Proposed magnet alignment changes for AP-1

February 2, 2001

James Morgan

AP-1 Vertical Survey with new nominal elevation

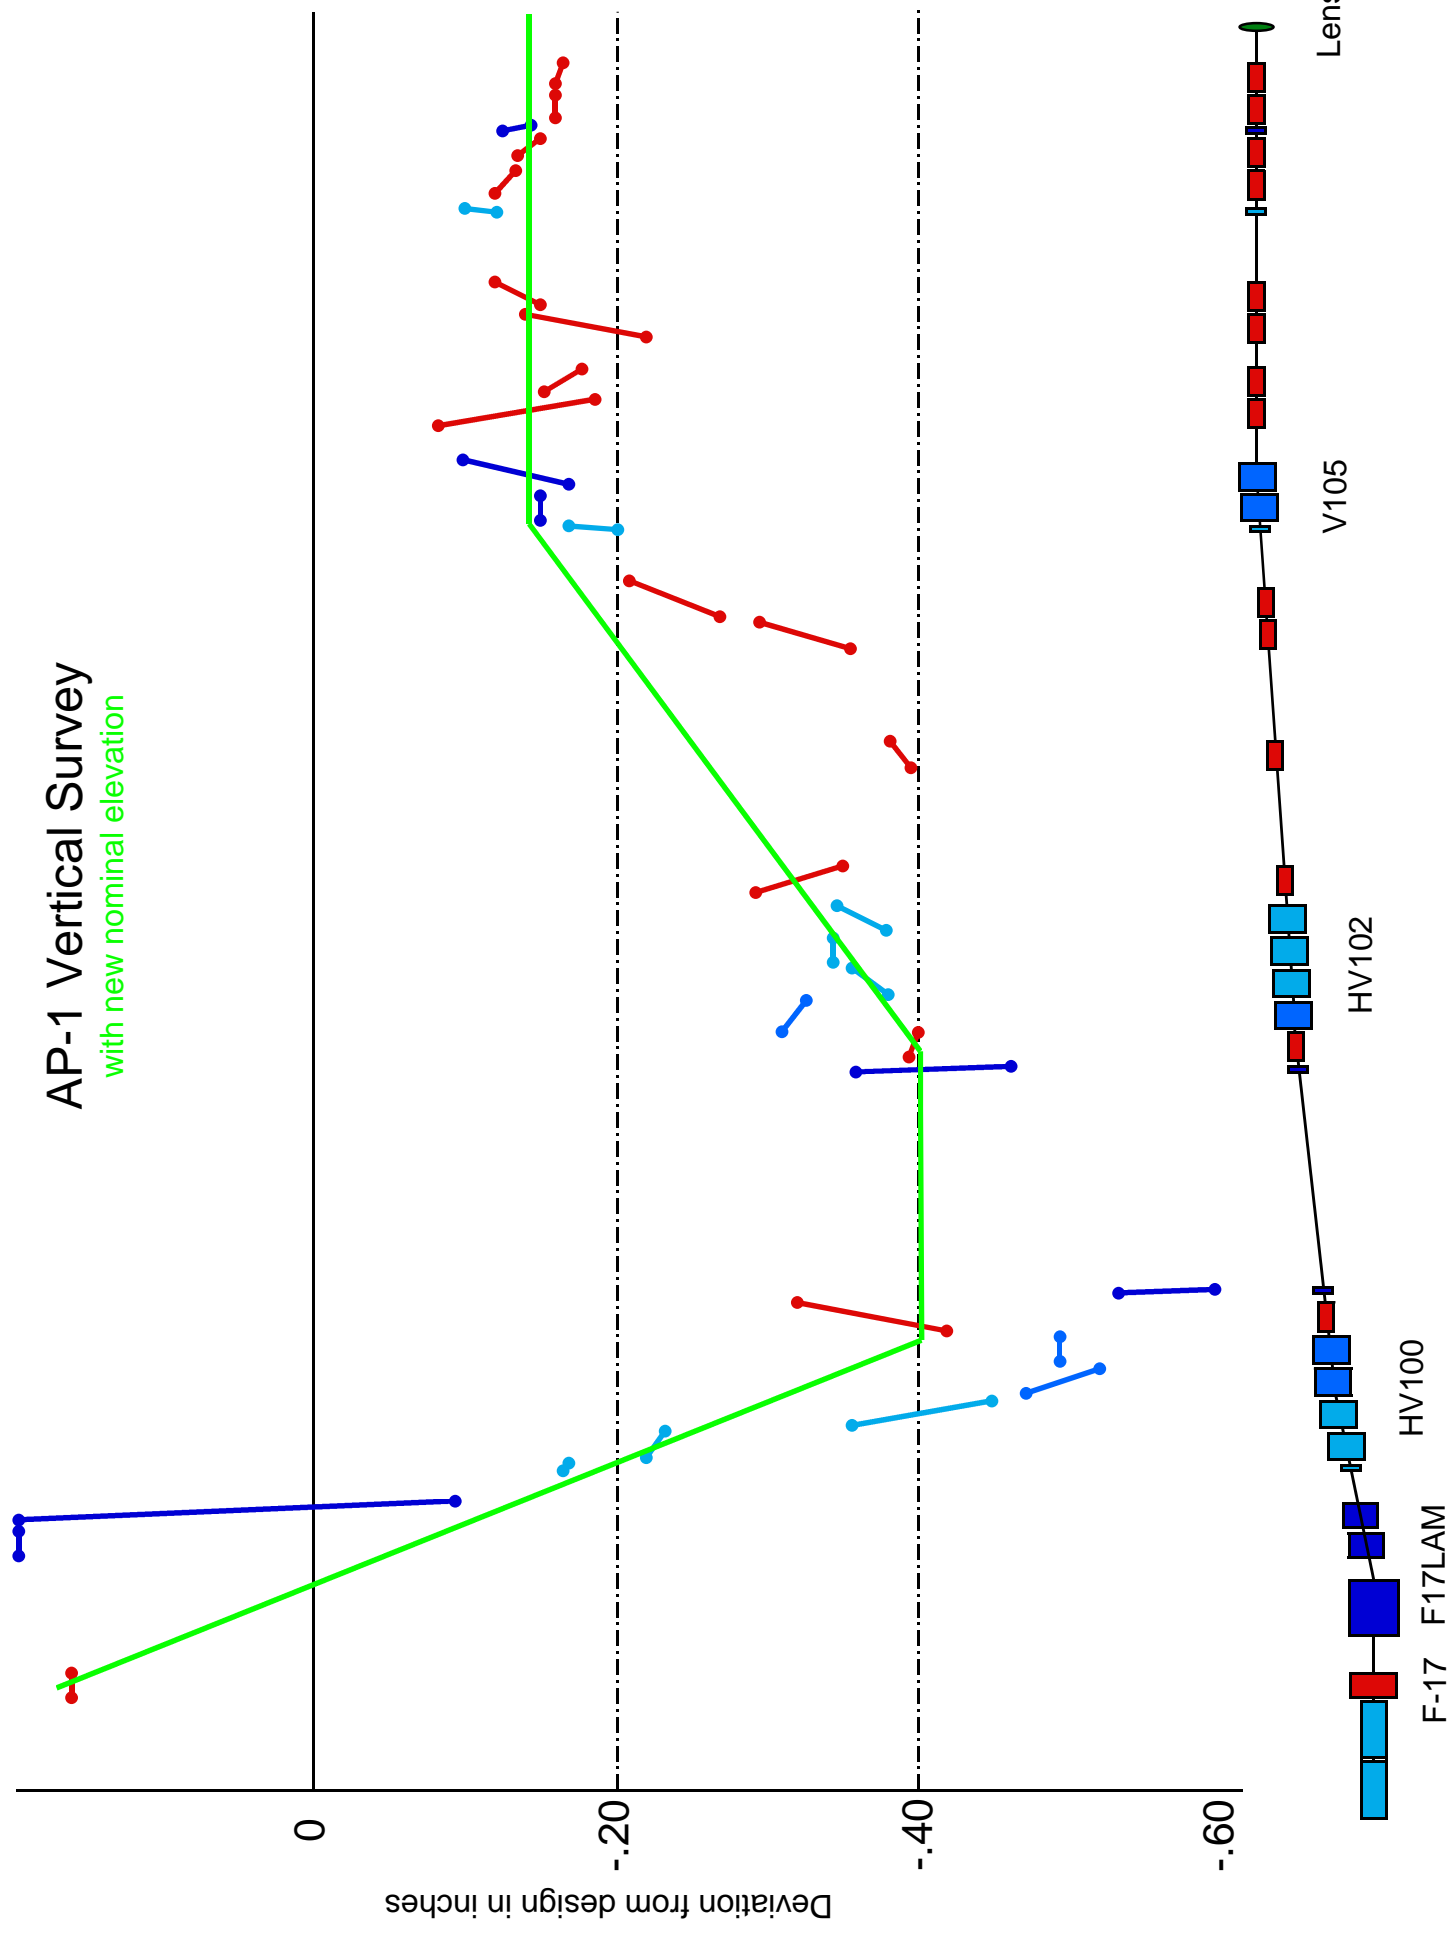
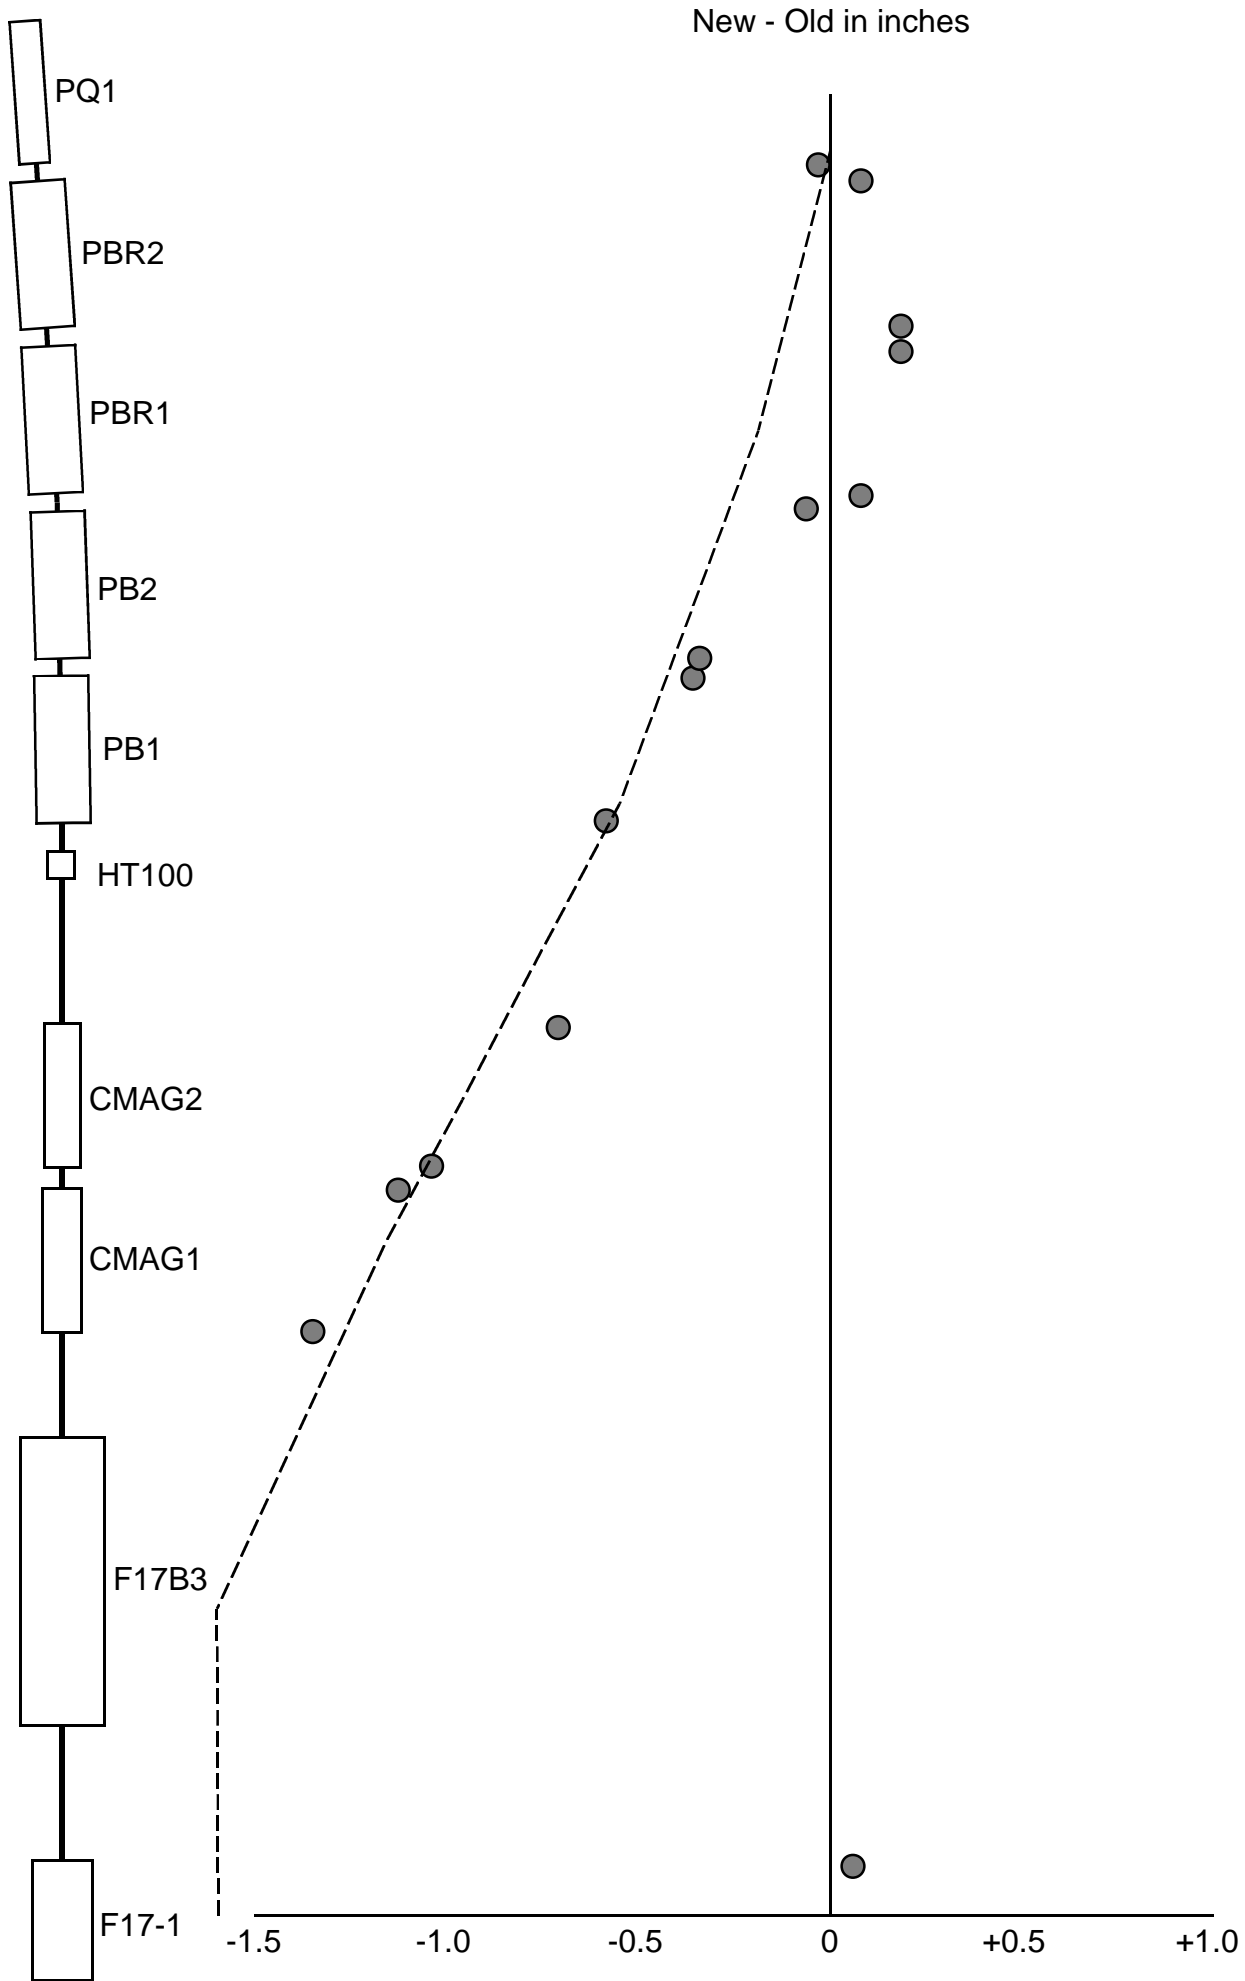
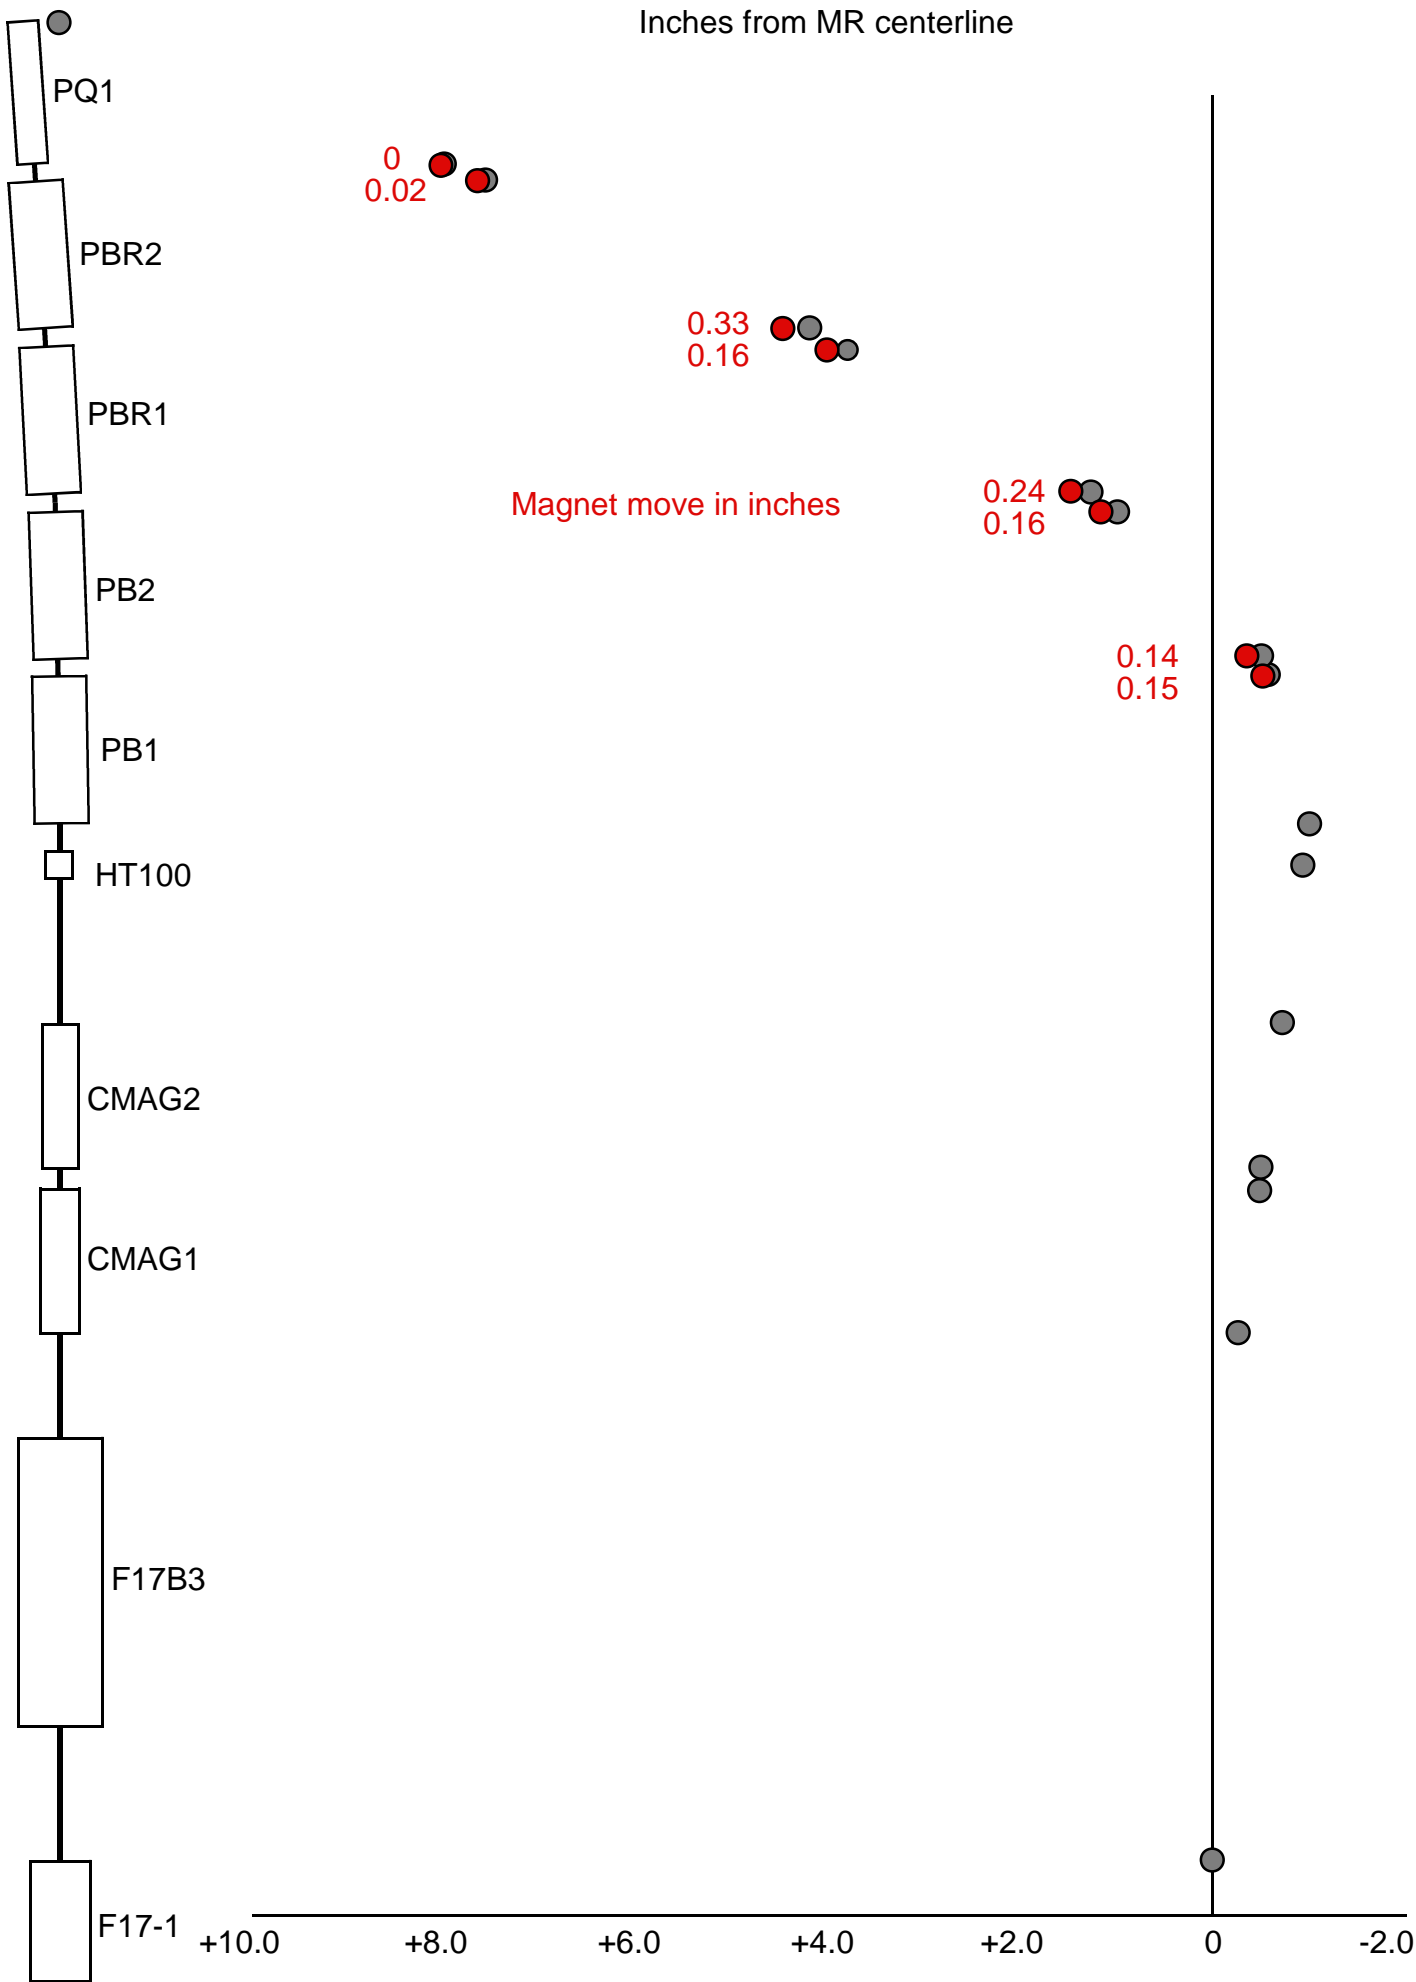
Examining the vertical survey results illustrated in Figure 3, the entire beamline is significantly below the original desired positions, perhaps due to settling. The quadrupoles approximately line up between vertical bend centers, which allows the line to work as well as it does. It would be far easier to create a new design trajectory that approximates the existing pattern than to force the magnets back to the original design. In figure 3 I have illustrated the new design trajectory with a green line. The largest deviations from the new desired trajectory is bend magnets PB2,3&4 and quadrupoles PQ4, PQ5A&B.
